IN THE DRAWINGS:

REMARKS

This is a full and timely response to the non-final Official Action mailed December 2, 2004. Reconsideration of the application in light of the following remarks is respectfully requested.

Fig 3

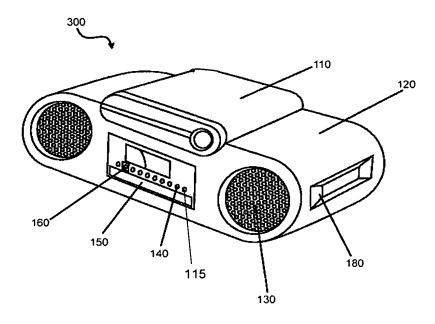
Applicant proposed herein to amend Fig. 3 to add reference number "115" and a reference line indicating an illustrated "indicator" as being element "115." Revised Fig. 3 is shown below. Additionally, a replacement drawings sheet is filed herewith. Approval of the proposed drawing change is respectfully requested.

Third, the Action states that the indictor of claim 19 is not clearly illustrated in Fig. 3. Consequently, Applicant has proposed herein to amend Fig. 3 to more clearly show the indicator recited in claim 19. The amendment to Fig. 3 is described above and a replacement drawing sheet has been filed herewith. No new matter has been added. Consequently, withdrawal of any objection to Fig. 3 or claim 19 is respectfully requested.

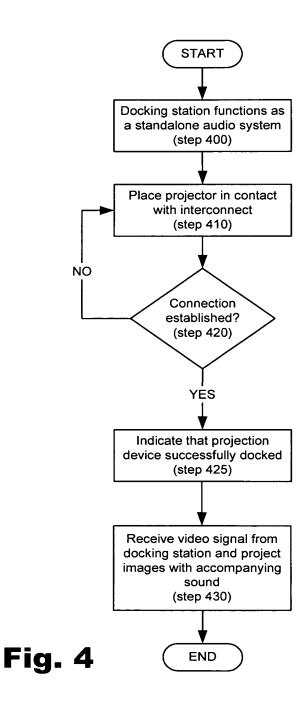
Applicant further proposes to amend Fig. 4, as shown below, to add step 425 "Indicate that projection device successfully docked" and to change step 430 to add the indicated language: "Receive video signal from docking station and project images with accompanying sound (step 430)." A replacement sheet bearing the amended Fig. 4 is also filed herewith.

Second, the Action questions whether step 420 in Fig. 4 is related to the subject matter of claim 4. Claim 4 recites that the "image projection device receives a video signal from said docking station via said electrical interconnect." Step 420 in Fig. 4 has been amended as indicated above to explicitly illustrate the subject matter of, for example, claim 4. No new

Fourth, the Action states that the method step of claim 30 is not illustrated in Fig. 4. Accordingly, step 425 has been added to Fig. 4 to explicitly illustrate the subject matter of, for example, claim 30. No new matter is added because claim 30 and other portions of Applicant's specification provide a basis in the application as originally filed for this amendment to Fig. 4. Consequently, any objection to Fig. 4 should be withdrawn.
